FINAL EXPRESS TERMS
FOR PROPOSED BUILDING STANDARDS
OF THE CALIFORNIA STATE LANDS COMMISSION
REGARDING THE 2019 CALIFORNIA BUILDING CODE,
CALIFORNIA CODE OF REGULATIONS, TITLE 24, PART 2
CHAPTER 31F – MARINE OIL TERMINALS
CHAPTER 35 – REFERENCED STANDARDS

(SLC-01-18)

FINAL EXPRESS TERMS

FIGURE 31F-2-1

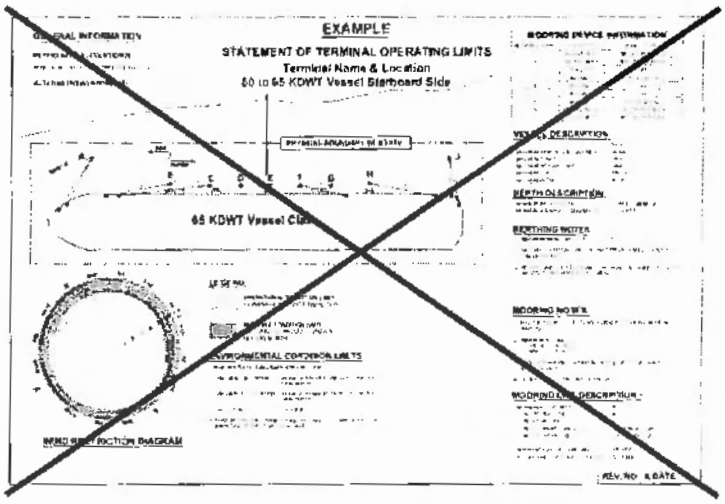
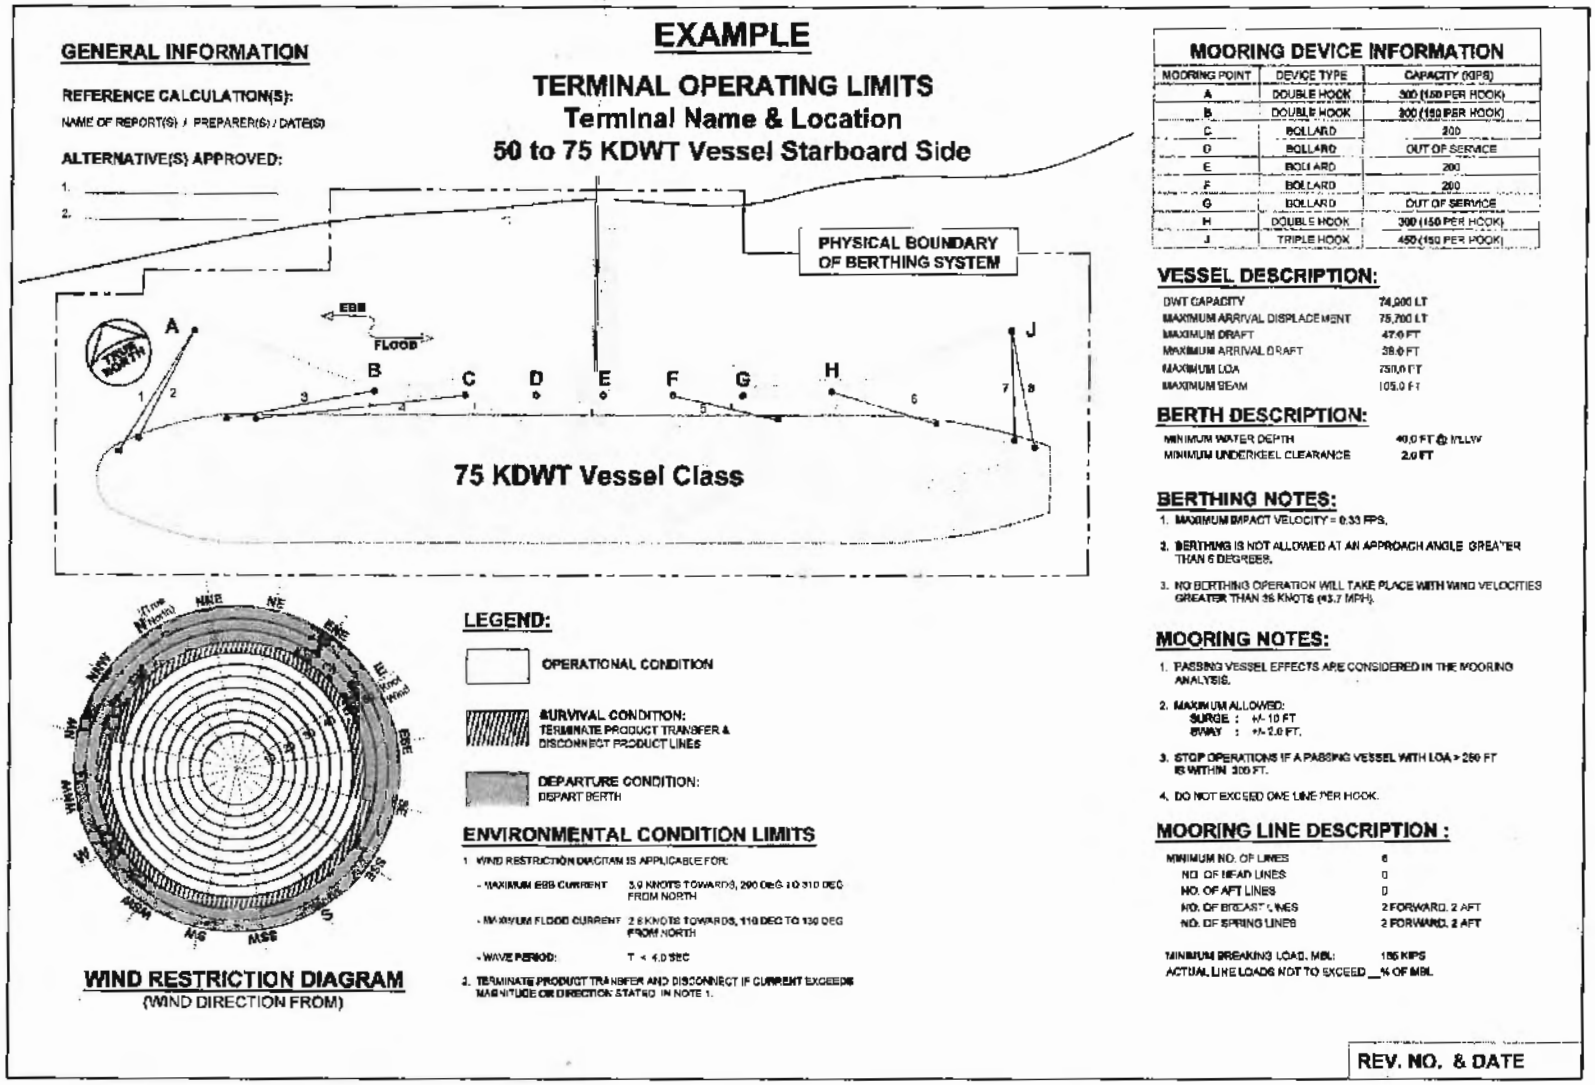
The audit shall include ~~a~~ "~~Statement of~~ Terminal Operating Limits~~,~~" (TOLs) diagrams, which ~~must~~ provide a concise statement of the purpose of each berthing system in terms of operating limits for representative vessel size ranges and mooring configurations approved to call and/or conduct transfer operations at the MOT. This description shall ~~must at least~~ include, the minimum and maximum vessel sizes, including Length Overall (LOA), beam, and maximum draft with associated displacement (see Figure~~,~~ 31F-2-1).

2.7. Remove entirely Figure 31F-2-1:

2.8. Replace Figure 31F-2-1:

FIGURE 31F-4-5
EFFECTIVE STIFFNESS FOR SUBSTITUTE STRUCTURE METHOD

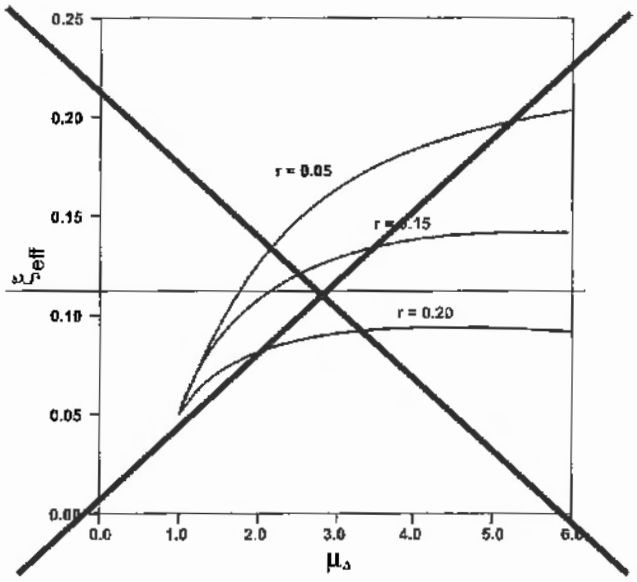
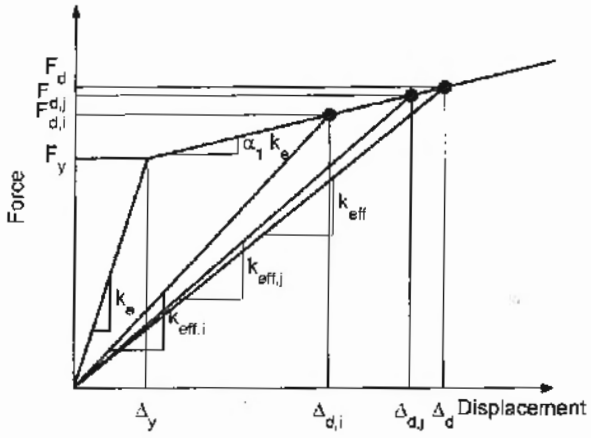
5. *The ductility level, $\mu_{\Delta,i}$ ~~μ_Δ~~, is found from $\Delta_{d,i}/\Delta_y$ ~~Δ_e/Δ_y~~. Use the appropriate relationship between ductility and damping, for the component undergoing inelastic deformation, to estimate the effective structural damping, $\xi_{eff,i}$ ~~ξ_{eff}~~. In lieu of more detailed analysis, ~~the relationship shown in Figure 31F-4-5 or~~ Equation (4-12)~~(4-10)~~ may be used for concrete and steel piles connected to the deck through dowels embedded in the concrete. Note that the idealized pushover curves in Figure 31F-4-4 shall be utilized in Figure 31F-4-5, which illustrates the iterative procedure.*

6. *Compute the force, $F_{d,i}$, on the force-deformation relationship associated with the estimated displacement, $\Delta_{d,i}$ (see Figure 31F-4-5).*

11. Repeat steps 5 to 10 with $\Delta_{d,i} = \Delta_{d,j}$ until displacement, $\Delta_{d,j}$, computed in step 10 is sufficiently close to the starting displacement, $\Delta_{d,i}$, in step 5 (Figure 31F-4-5).

4.8. Remove entirely:

4.9. Add new Figure 31F-4-5:

~~*FIGURE 31F-4-6*~~
~~*DESIGN DISPLACEMENT RESPONSE SPECTRA*~~

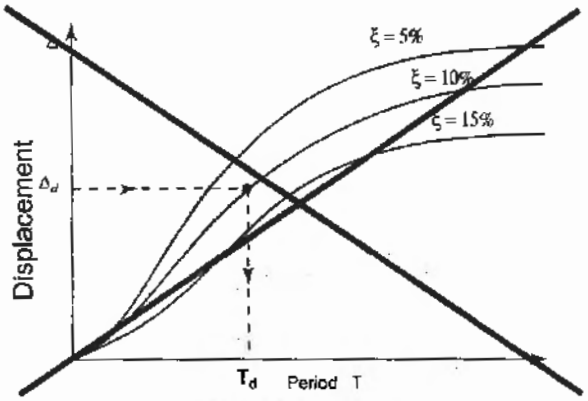
~~7. Using the curve applicable to the effective structural damping, ξ_{eff}, find the effective period, T_d (see Figure 31F-4-6).~~

4.10. Remove entirely:

~~*FIGURE 31F-4-7*~~
~~*EFFECTIVE LATERAL STIFFNESS (ADAPTED FROM [4.4])*~~

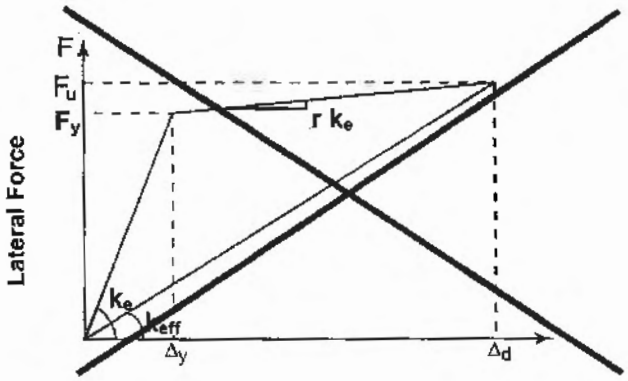
~~12. Repeat the process until a satisfactory solution is obtained (see Figure 31F-4-7).~~

4.11. Remove entirely:

FIGURE 31F-4-9
AMPLIFICATION FACTOR, a_p [4.10]

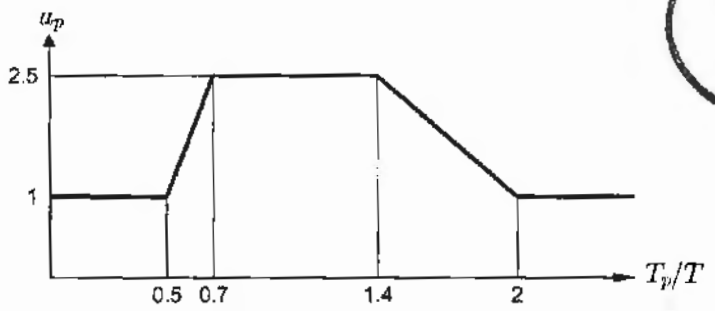
1. A lower value shall not be used unless justified by detailed dynamic analysis, and shall in no case be less than 1.0.
2. If the fundamental period of the MOT structure, T, and the period of the flexible nonstructural component or nonbuilding structure, T_p, is known, a_p may be estimated 24) from Figure 31F-4-9.

4.30. Add new Figure 31F-4-9:

FIGURE 31F-7-4
METHOD A – MOMENT CURVATURE ANALYSIS

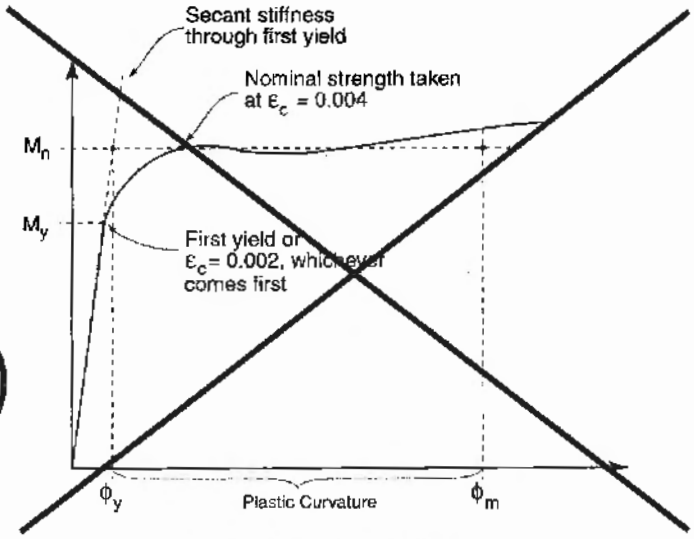
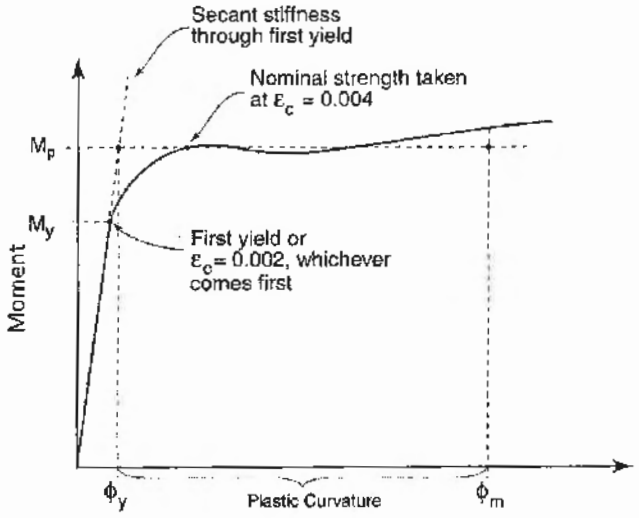
7.7. Remove entirely:

7.8. Add new Figure 31F-7-4:

~~M_{cr} is defined in Figure 31F-7-4.~~
